**ZP-24-87; 63 Lakeview Terrace (RM, Ward 2) Barbara Zucker / Louis Lionni / Joe Fisher
Proposed two-story addition with basement and elevator. (Project Manager, Scott Gustin)**

MEMORANDUM

To: Design Advisory Board
From: Scott Gustin
Re: 63 Lakeview Terrace
Date: May 14, 2024

Request: Proposed 2-story rear addition to existing single family home.

Title
EXTERIOR ELEVATIONS
Sheet Number

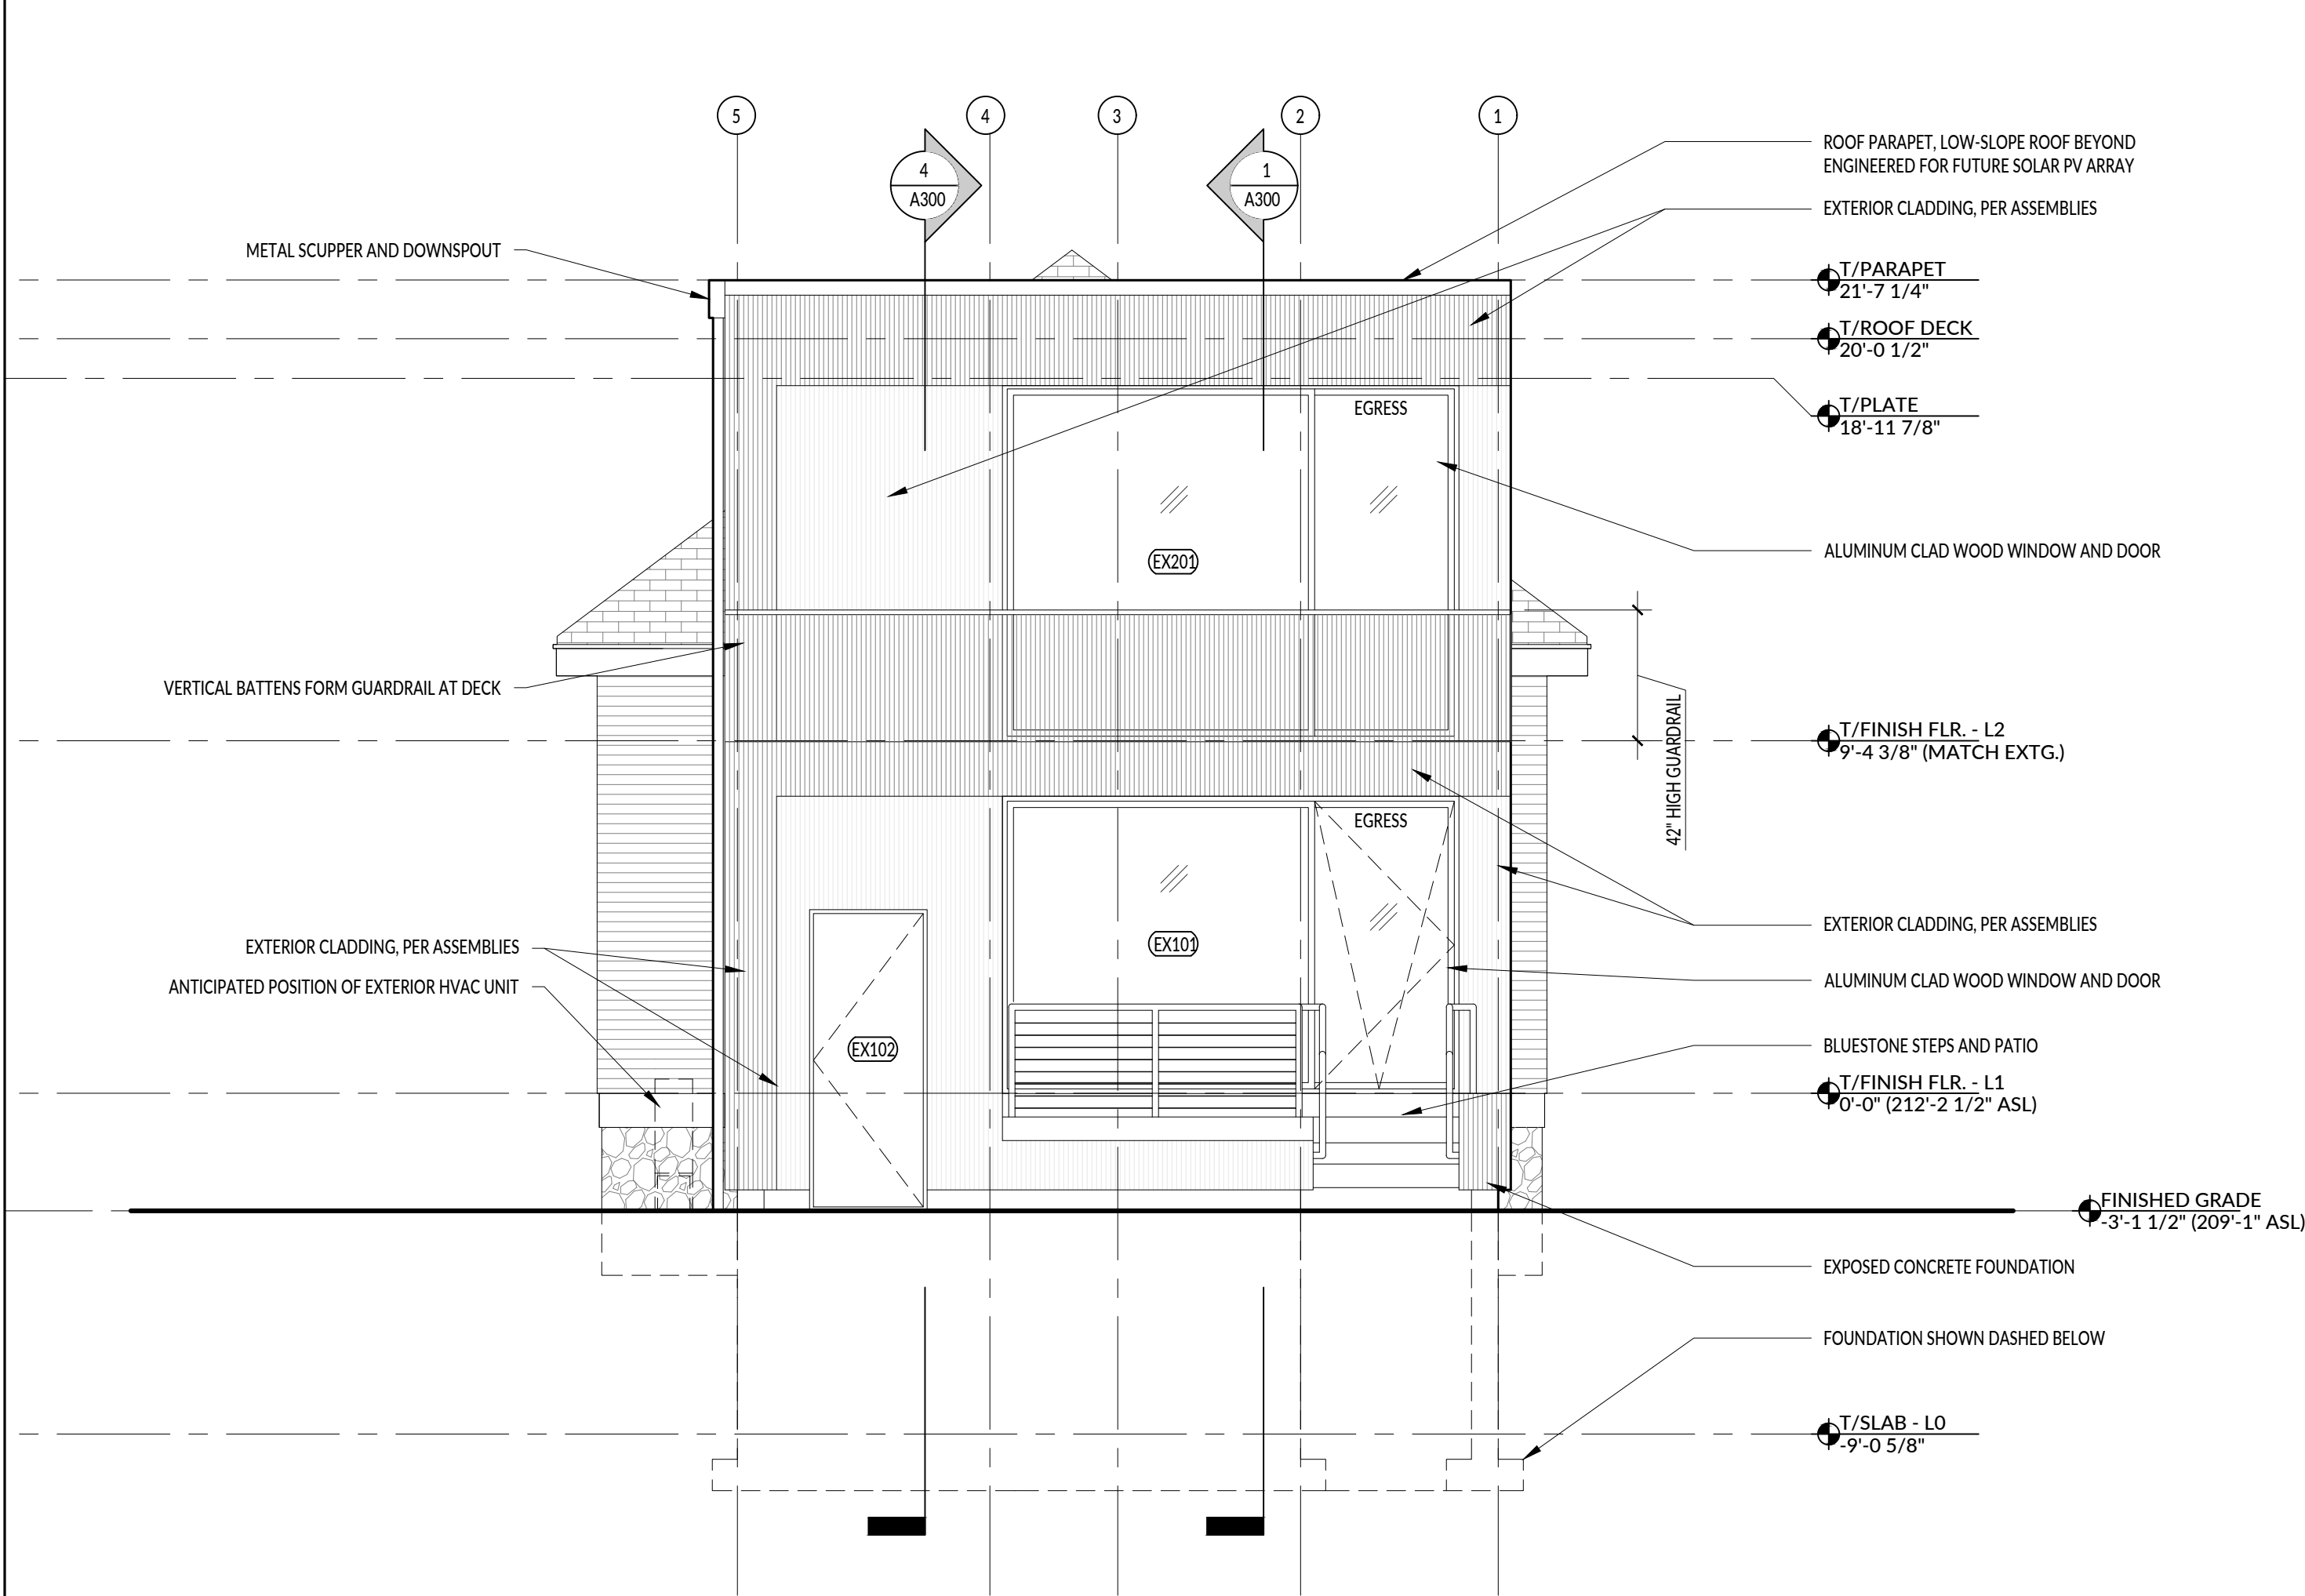
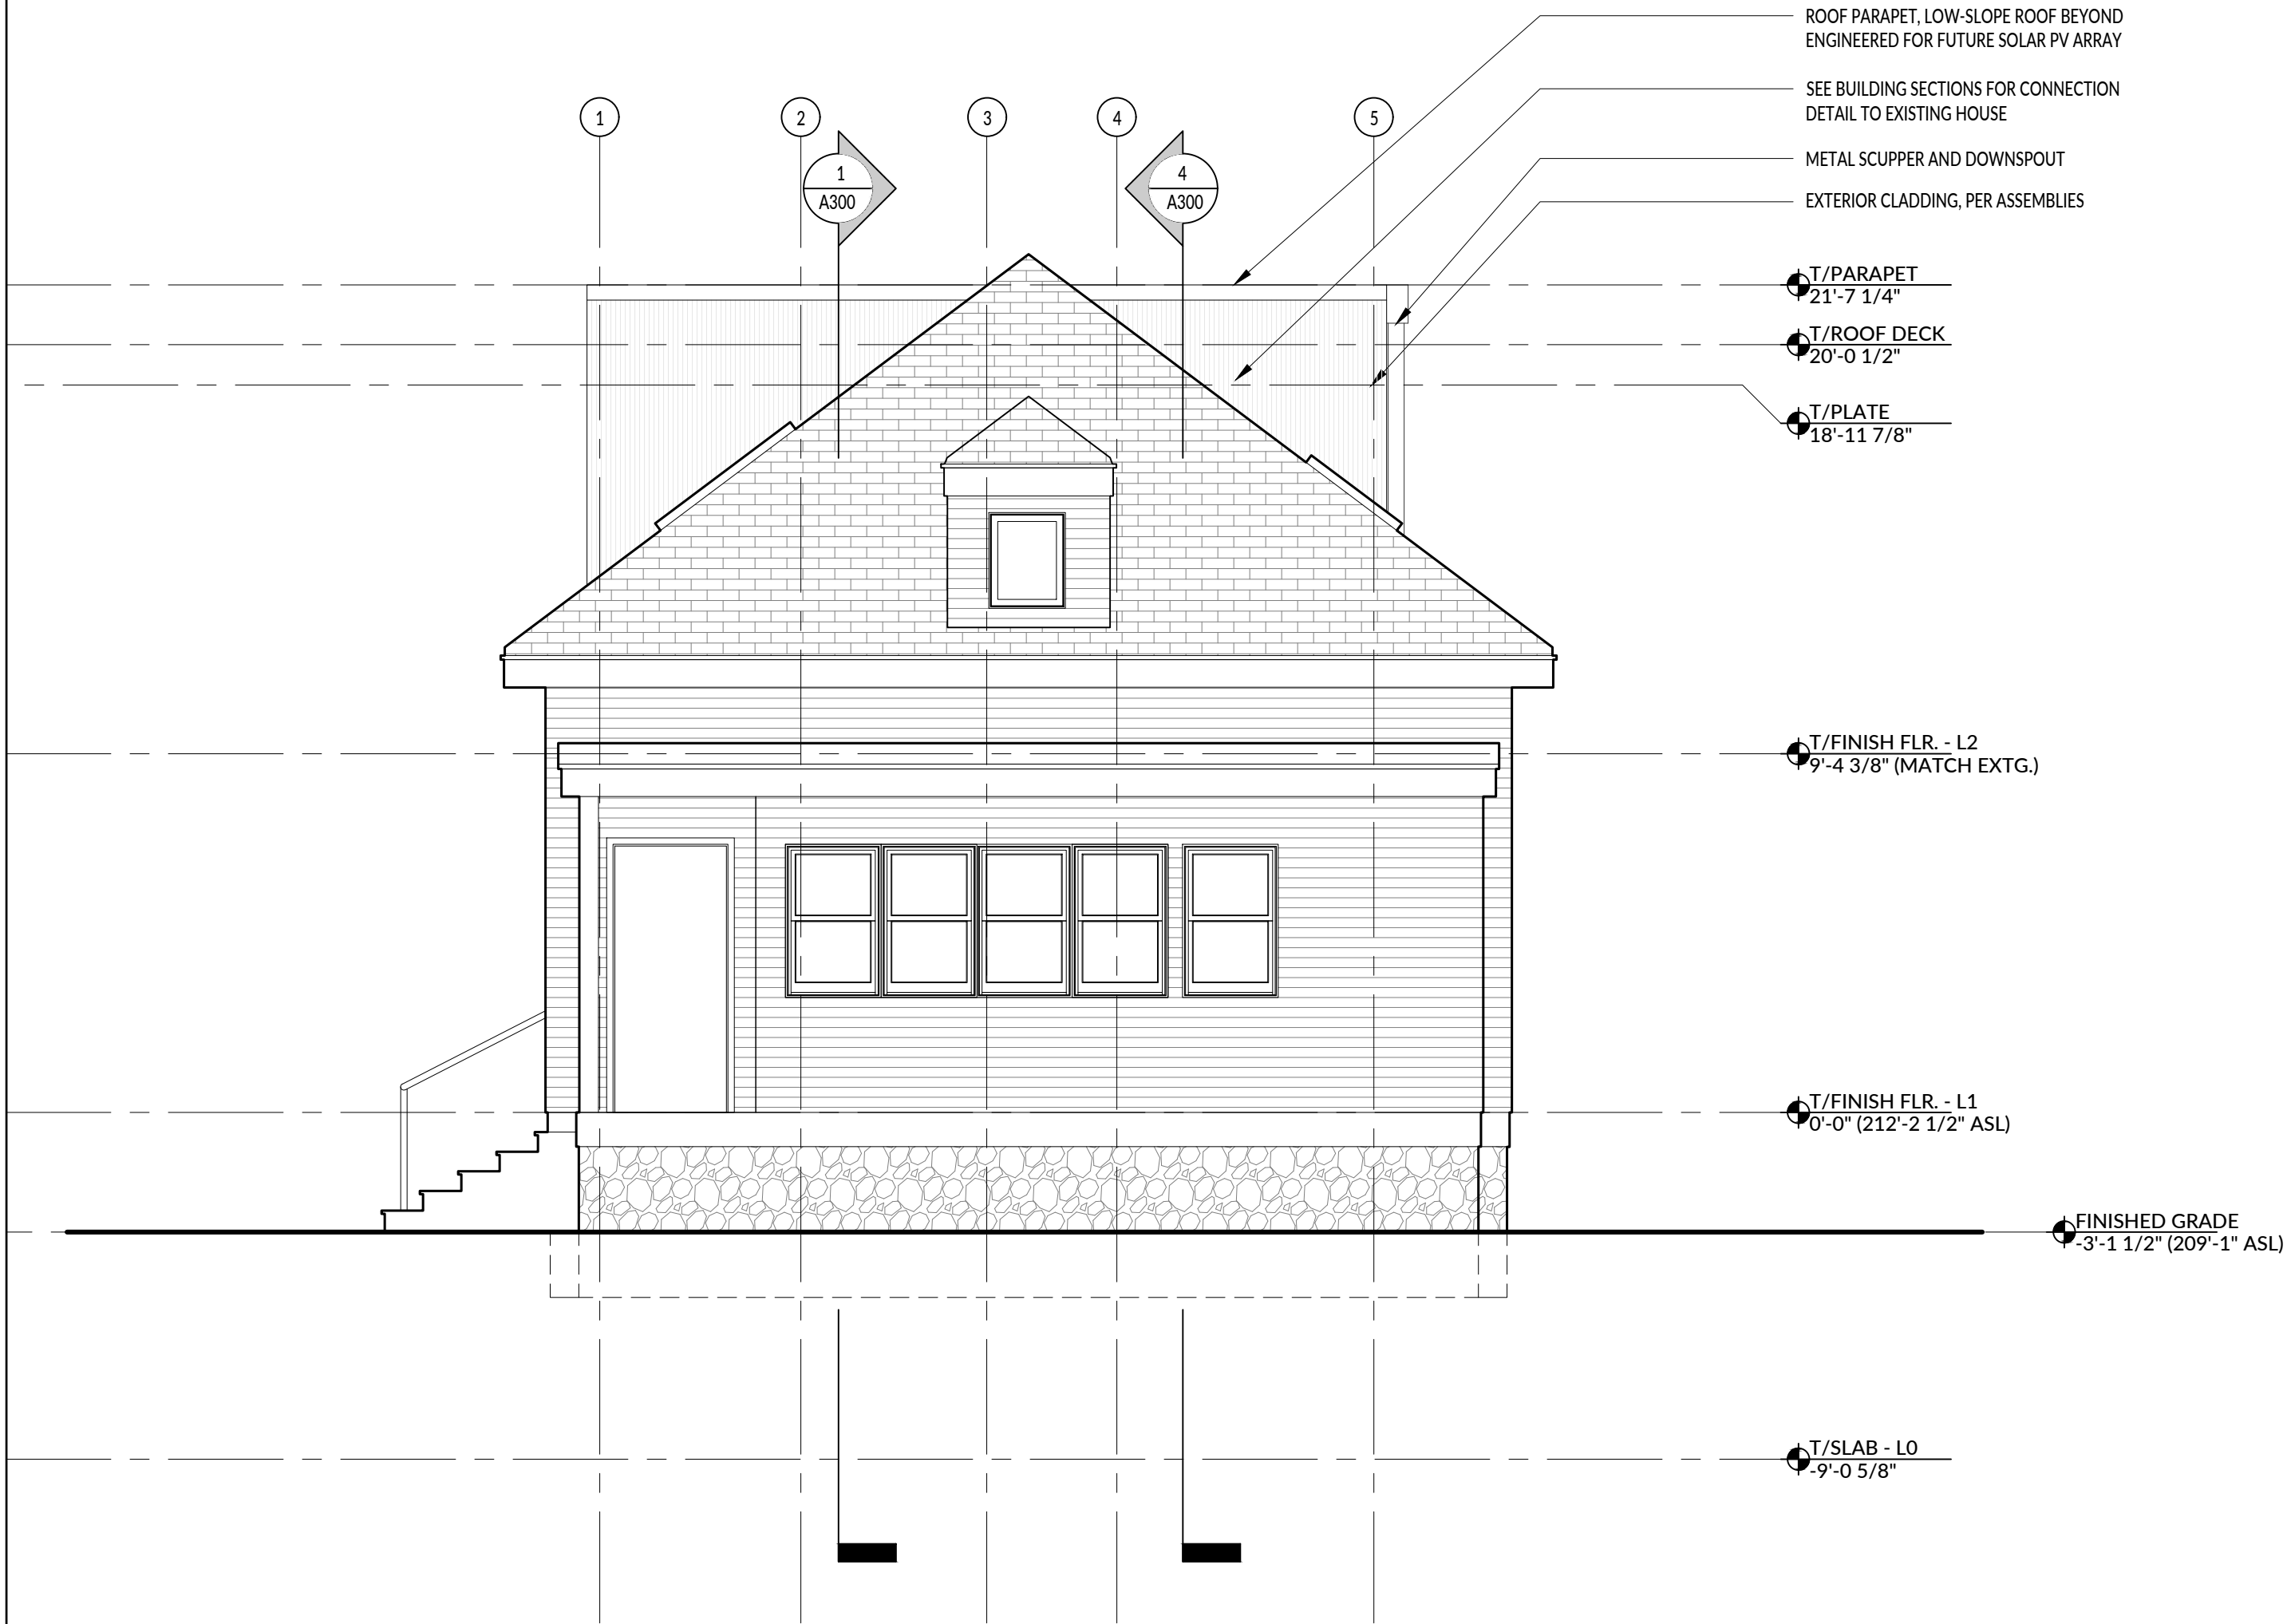
The elevation plans include notation that the addition roof will be constructed to support a future solar array. The property appears to be well situated for solar energy capture, and installation of such array is encouraged.

New outdoor lighting is included in this application. Some fixture information is provided in the project details that depict a canister fixture and a step light. No illumination information is evident, nor is fixture location shown. The fixtures are likely acceptable; however, lumen information is needed to determine compliance with Sec. 5.5.2, *Outdoor Lighting*, and fixture locations need to be depicted on the project plans.

As with the rest of the addition, proposed fenestration is a departure from that in the original home. Both side elevations include large windows screened behind the siding battens. As noted above, the western elevation contains ample glazing to take advantage of expansive views across the downtown waterfront and beyond. The proposed fenestration appropriately contributes to the design of the addition.

The addition will make use of existing utilities serving the property. No roof-top equipment is evident. Two exposed downspouts are located along the northern elevation and will be painted to match the siding.

1. Provide additional detail as to vegetation removal and new vegetation installation, including the extent of vegetation to be removed and species and size of new plantings.
2. Provide outdoor lighting fixture locations and lumen levels.
